HISTORIC AND DESIGN REVIEW COMMISSION

February 21, 2018

HDRC CASE NO: 2018-007
ADDRESS: 527 E HUISACHE AVE
LEGAL DESCRIPTION: NCB 3090 BLK 6 LOT 26
ZONING: MF-33 H
CITY COUNCIL DIST.: 1
DISTRICT: Monte Vista Historic District
APPLICANT: David Bogle, R.A., AIA/SYNCRO Architecture Studio
OWNER: Grant Garbo
TYPE OF WORK: Construction of a rear addition, construction of front porch, exterior alterations, hardscaping and landscaping
APPLICATION RECEIVED: February 02, 2018
60-DAY REVIEW: April 03, 2018
REQUEST:

1 Site Plan - Proposed Option 5
1/8" = 1'-0"

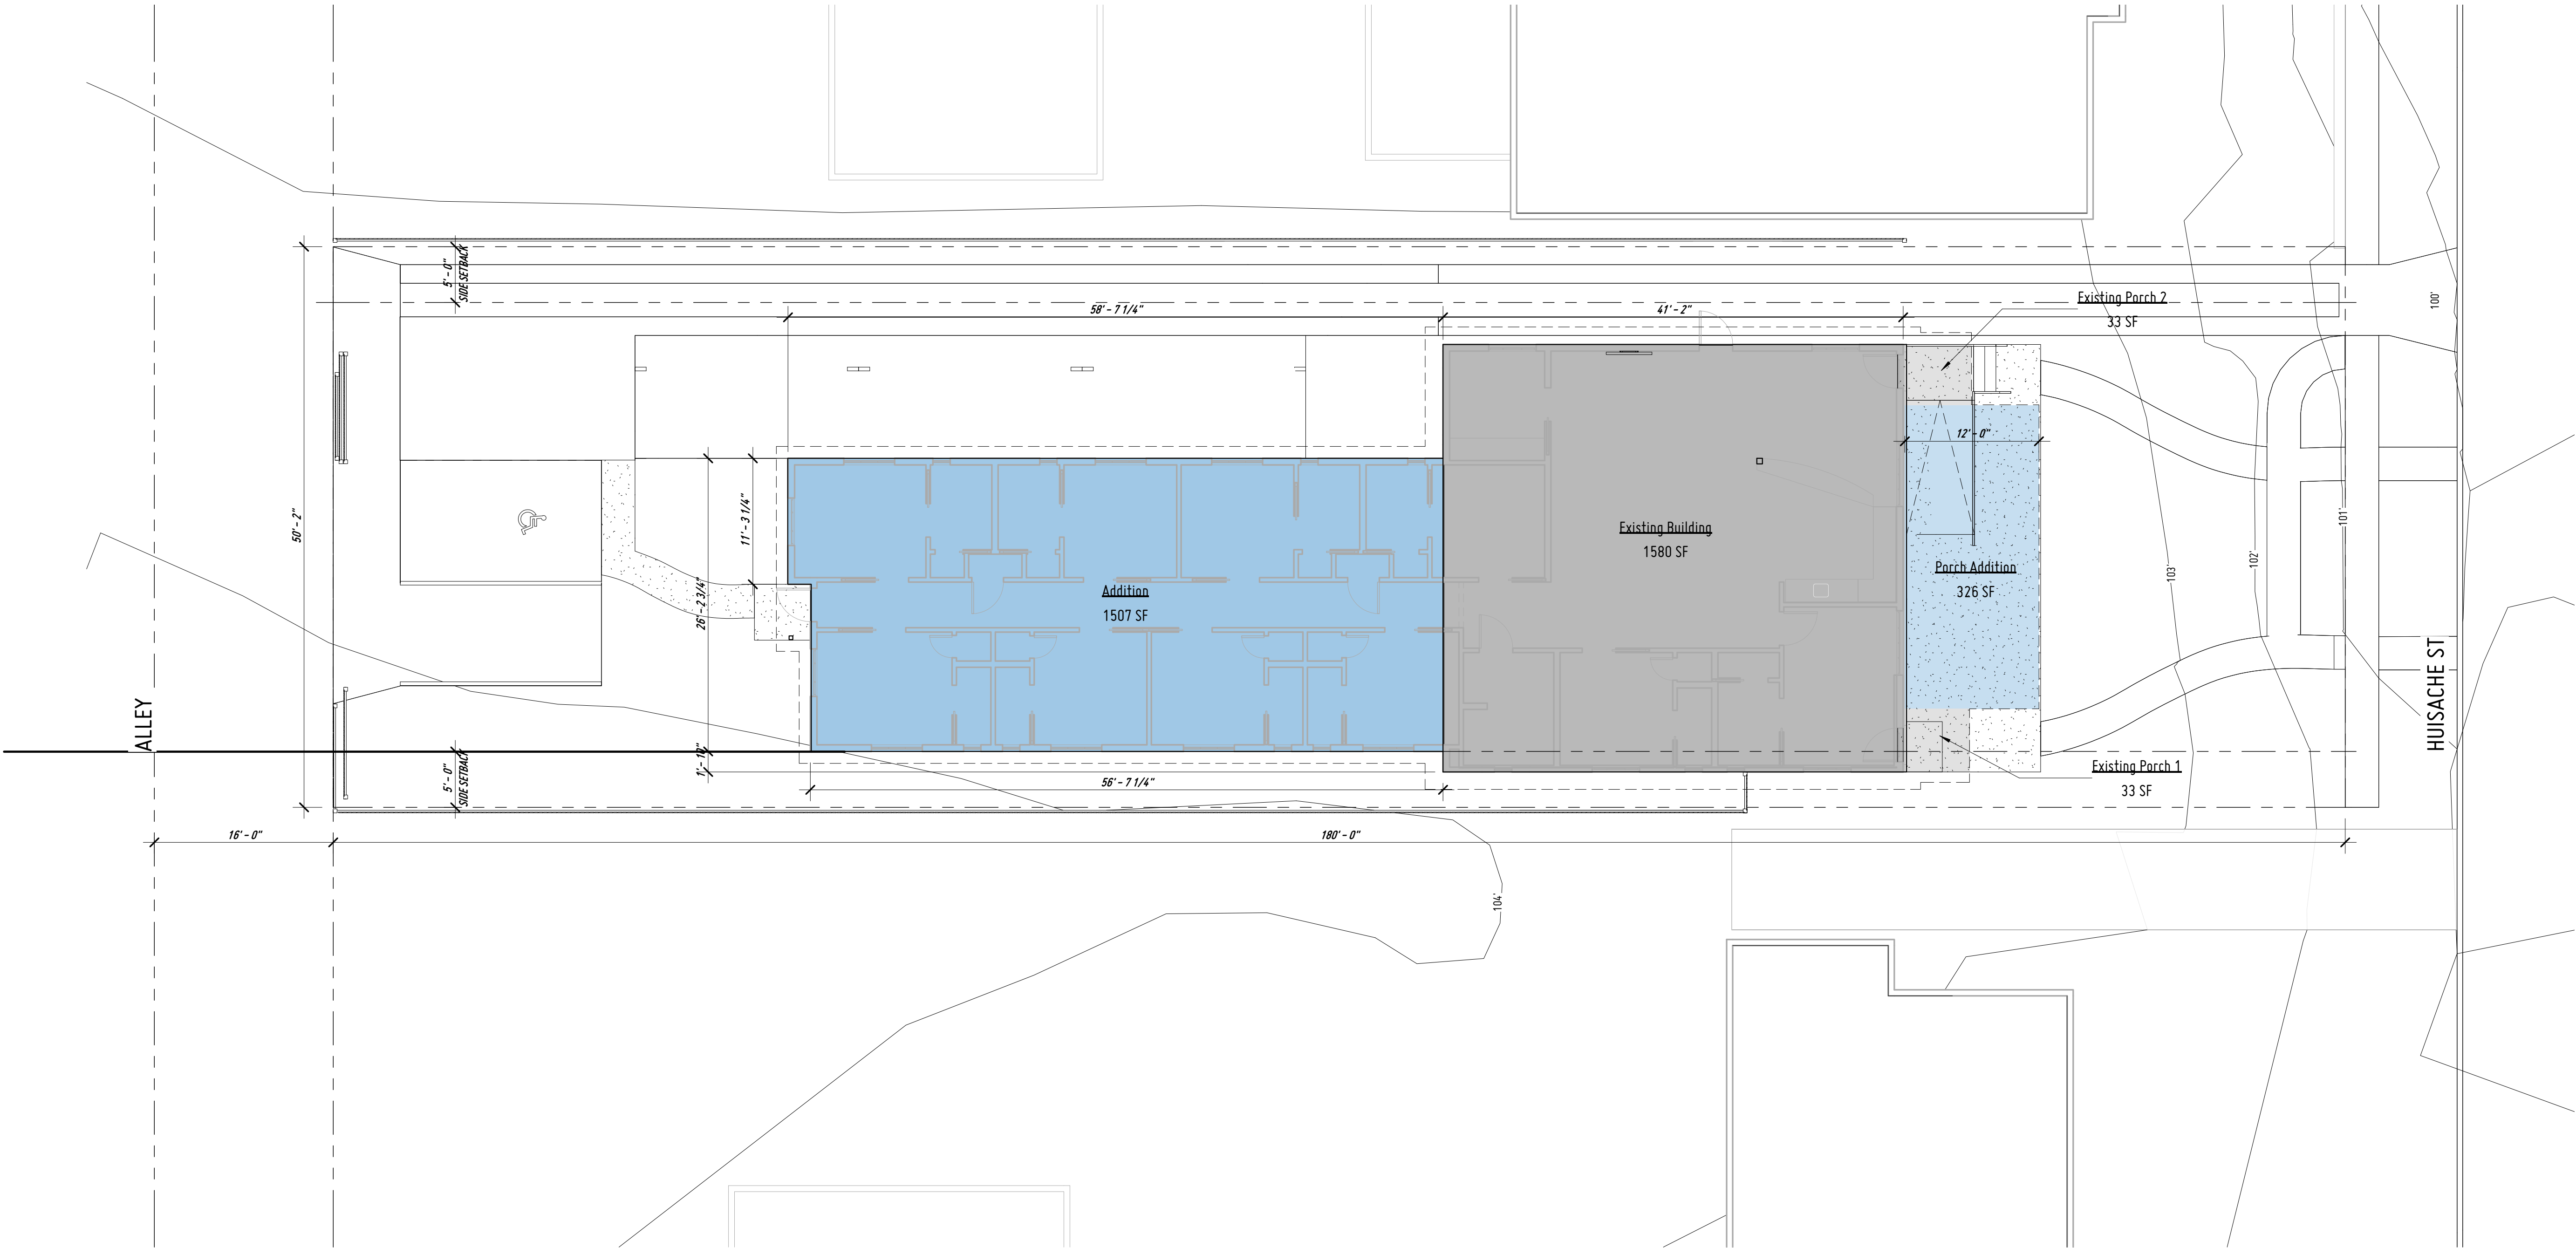
- o. **DRIVEWAY MODIFICATIONS** – The applicant has proposed to extend the existing concrete ribbon driveway through the lot to connect to the rear alley. The driveway will create a through-site condition. No modifications to the width or configuration of the ribbons or the existing curb cut and apron are proposed. According to the Historic Design Guidelines, the historic alignment, configuration, and width of driveways should be preserved. The predominant development pattern is a front driveway that terminates at a rear accessory structure. In some cases, alley access is provided to rear accessory structures. There is no precedent in the neighboring blocks of E Husiache and E Mulberry for the driveway to extend through the site. Staff does not find the proposal appropriate.

- r. **REAR HARDSCAPING** – The applicant has proposed to install a rear hardscaping to accommodate parking, an accessible walkway, and an ADA accessible drop-off area. The hardscaping will be a combination of pervious (gravel) and impervious (concrete) coverage. The impervious concrete will connect to the proposed extended ribbon driveway and create an ADA accessible parking space with a drop of zone, located adjacent to the rear alley. The concrete will extend from this parking area to create an accessible walkway to the rear entrance of the proposed new addition. The pervious gravel will be located to the west of the proposed new addition and will create space for three parked cars. An additional gravel space will be added east of the concrete ADA parking space. According to the Historic Design Guidelines, off street parking should be located at the side or rear of a structure whenever possible. There is also evidence of existing parking pads along the alley. Staff finds that the concept of a rear parking area is generally consistent with the Guidelines, but the rear hardscaping as proposed, when coupled with the proposed addition's impervious cover, removes a significant portion of the rear landscape. While some properties on E Huisache, Kings Ct, and E Mulberry feature extensive hardscaping in the rear of the lot, the predominant development pattern is a rear yard with a majority grass or trees and other plantings with rear accessory structures or additions. Staff finds that the applicant should reduce the amount of hardscaping due to the additional impervious changes proposed to the lot.

- s. **REAR CURB CUT** – The applicant has proposed to install a new rear curb cut and apron to provide access to the rear parking pads. While the submitted site plan does not indicate the dimension of the width of the curb cut, it appears to extend from the eastern edge of the lot to approximately eight feet from the western edge of the lot. This totals approximately 75% of the width of the rear lot line. According to the Historic Design Guidelines, new curb cuts should not be introduced where historically found. If introduced, they should be consistent with historic curb cuts in the district. There is evidence of curb cuts that are wider than ten feet along the rear alley, but there is no precedent for a rear curb cut that extends nearly the full width of the lot to provide direct access to parking pads. Staff finds that applicant should explore ways to reduce this width.

① Elevation - Proposed - South
1/4" = 1'-0"

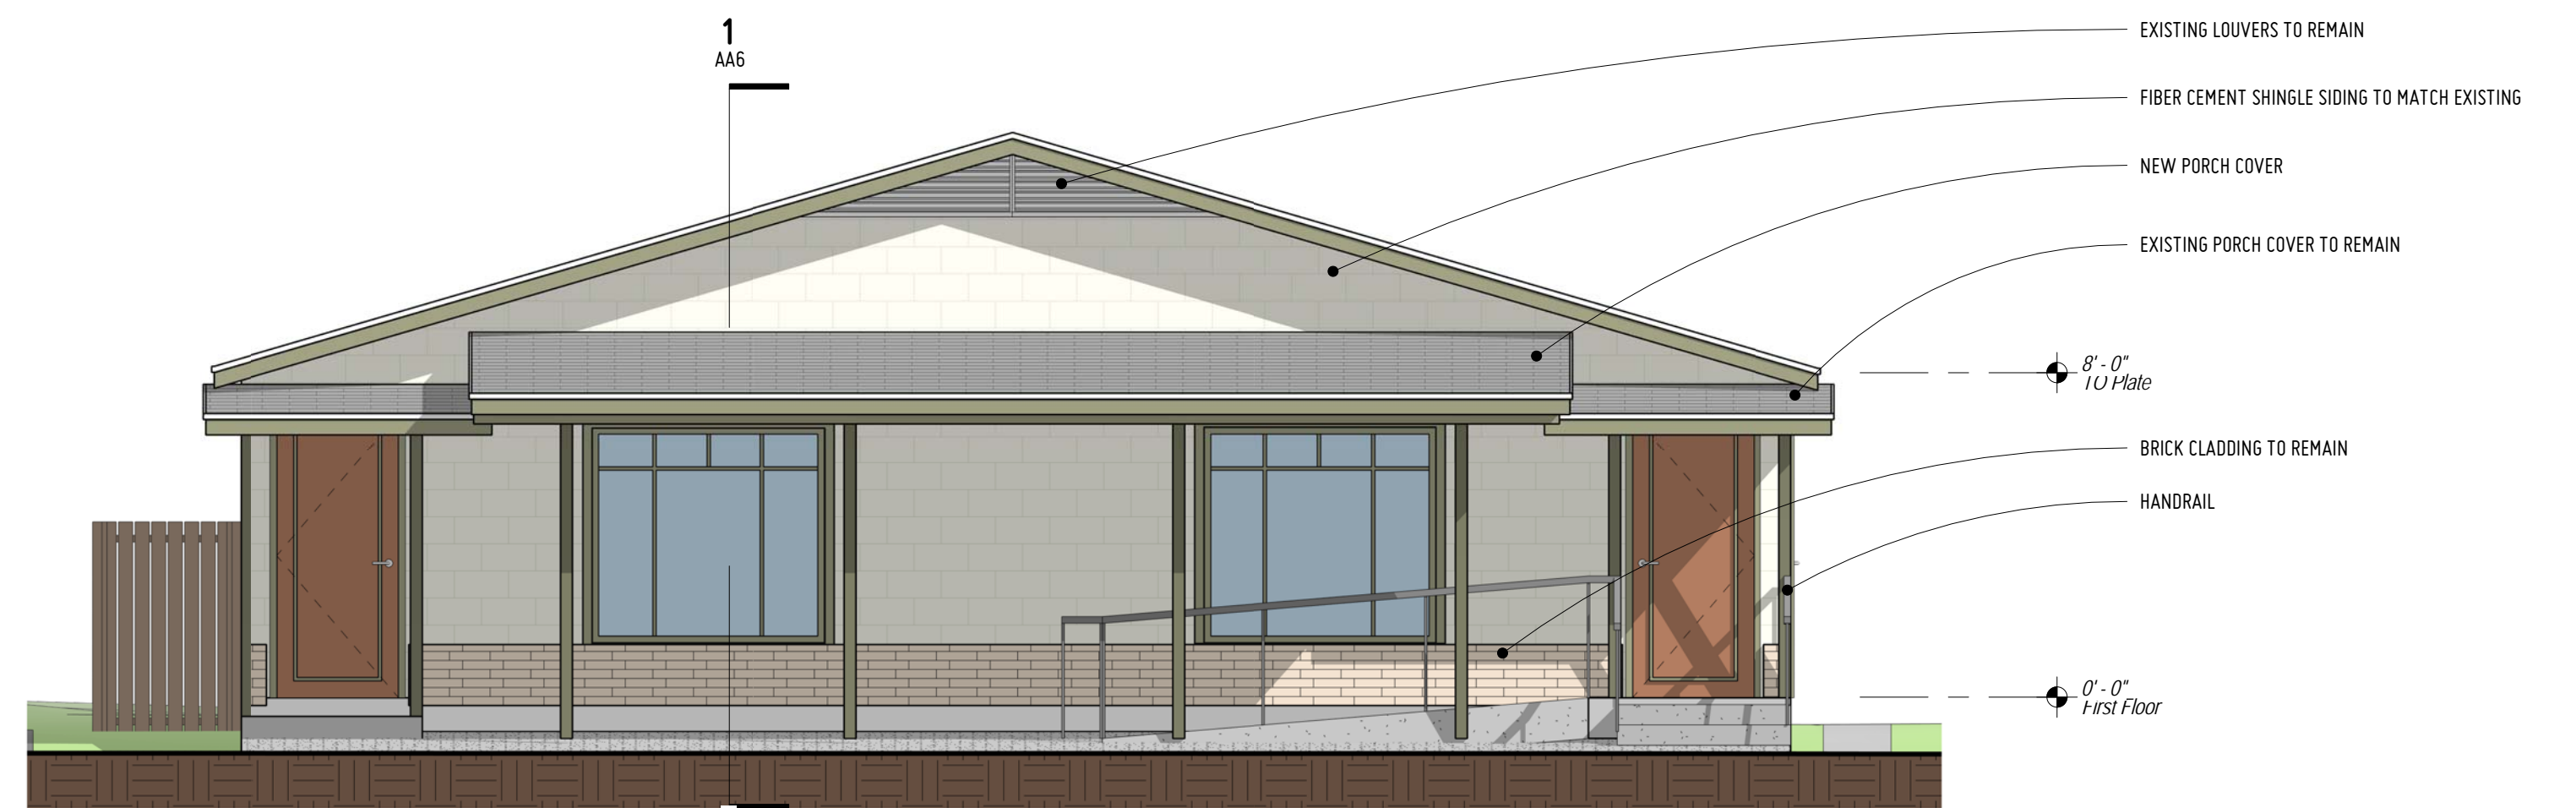
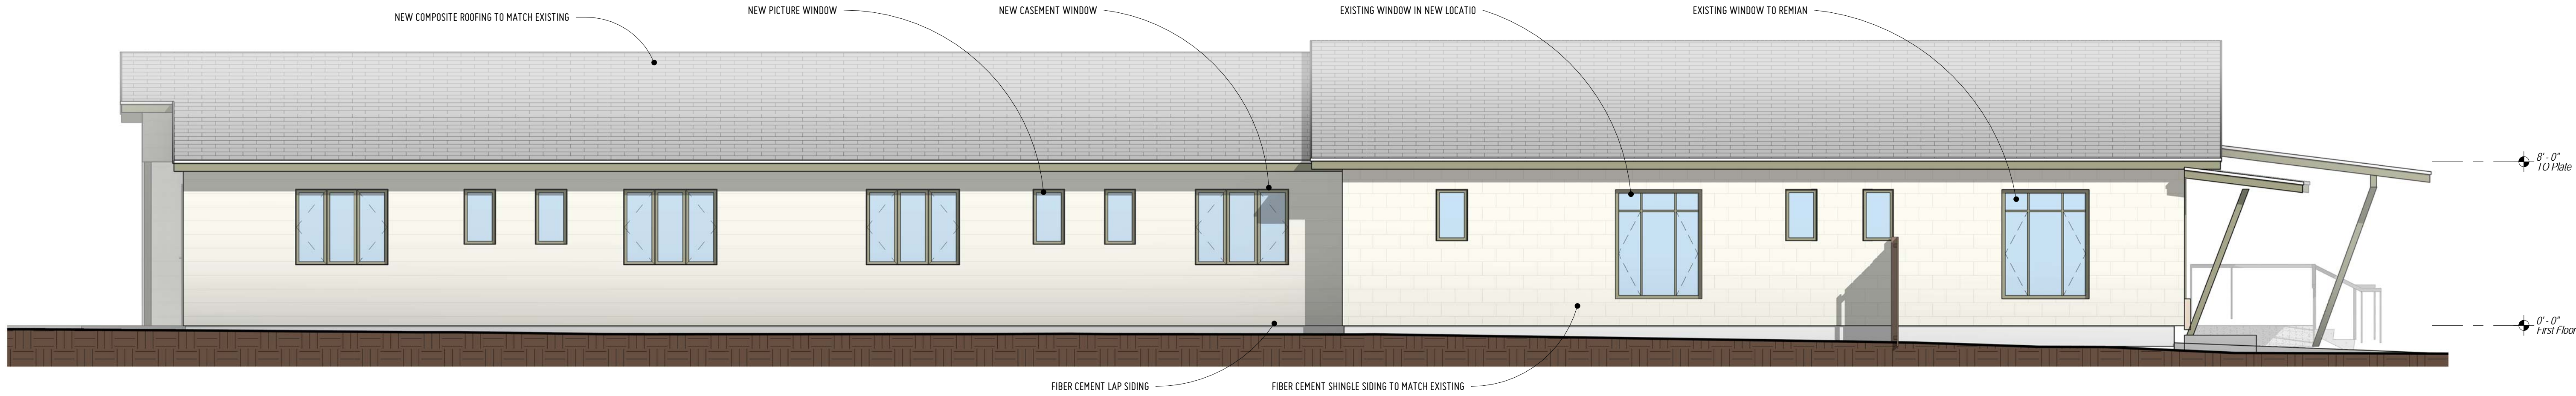
- m. **FRONT PORCH** – The applicant has proposed to construct a new front porch. The front façade currently contains two small shed awnings above each door, which will be preserved. The proposal will add a new shed awning that spans between the two existing awnings. The new awning will extend approximately double the width of the existing awnings to engage the streetscape and create a true covered porch condition. The proposal also includes extending the concrete porch decking towards the street for a total footprint of 459 square feet. According to the Historic Design Guidelines, new porch elements, including stairs and related elements, should be simple and not distract from the historic character of the building and should be architecturally appropriate for the home. Historic examples on the block that contain wide porches incorporate alternate roof forms, such as a simple shed or hip, or exhibit roof proportions that mimic the primary gable. Additionally, because the existing structure is set back from the front façades of its neighbors, the extended footprint of the porch will not protrude past neighboring historic structures. Staff finds the porch and footprint to be conceptually consistent.

- n. **FRONT ADA RAMP** – The applicant has proposed to install a new ADA accessible ramp on the front façade of the existing structure. The ramp will be covered by the proposed porch and will be located on the eastern edge of the structure. According to the Historic Design Guidelines, the preferred location of new ramps on a residential structure is at the side or rear of the building when convenient for the user. However, the applicant has modified the ramp's design from their previous submissions to create a ramp that is light in its design and minimally intrusive from the public right-of-way. Staff finds the proposal conceptually consistent.

③ Elevation – Proposed – West Copy
1/4" = 1'-0"

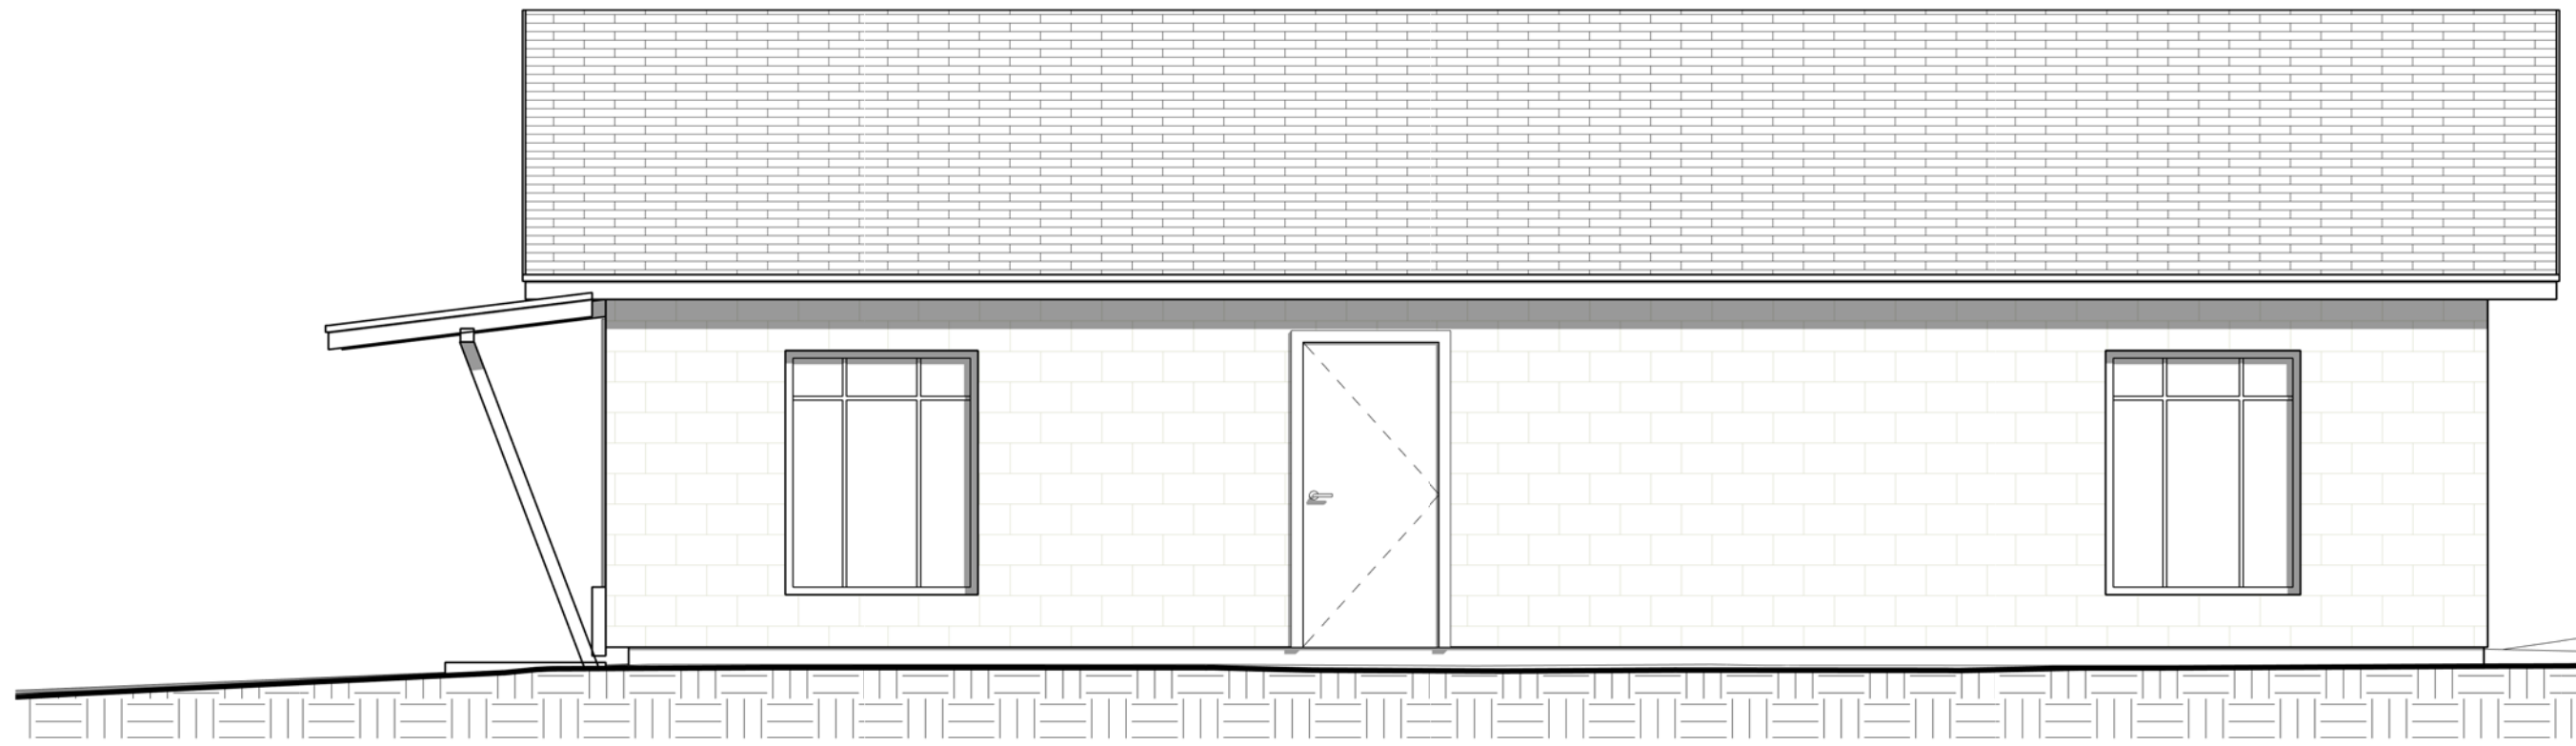
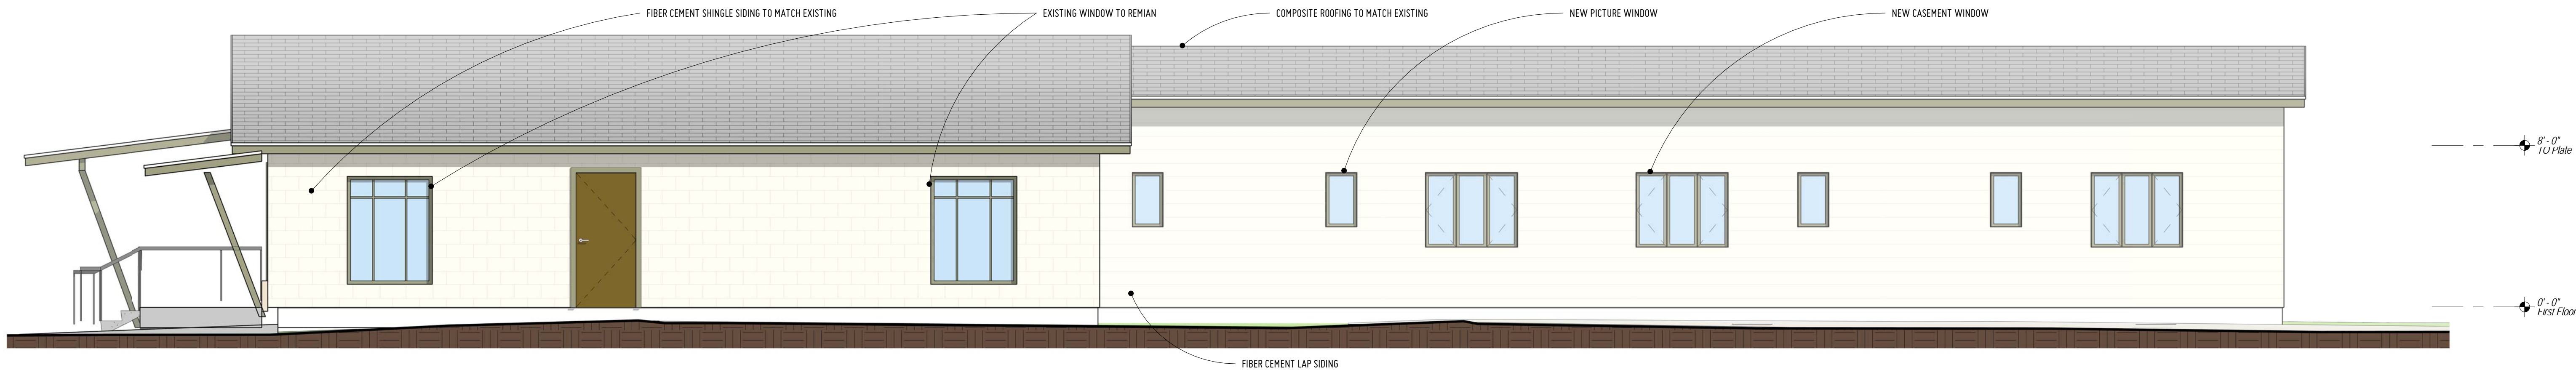
- i. **MATERIALS: FAÇADE** – The existing structure features asbestos lap siding with a wide exposed profile of approximately 12 inches. The applicant has proposed to remove the siding on the rear, west, and east elevations and install lap fiber cement siding on both the existing structure and the addition. The applicant has proposed to retain the asbestos siding on the front elevation if the new construction does not require its removal due to impact. Staff finds the proposal generally appropriate and finds that smooth boards and an exposure of no more than 8 inches should be used.

- j. **TRANSITIONS BETWEEN OLD AND NEW** – The proposed addition will be inset on the west façade from the historic structure by approximately two feet. On the east façade, the structure will be inset by approximately 10 feet. According to Guideline 2.A.v for Additions, rear additions should utilize setbacks, a small change in detailing, or a detail at the seam of the historic structure and addition to provide a clear visual distinction between old and new building forms. The proposal meets this Guideline.
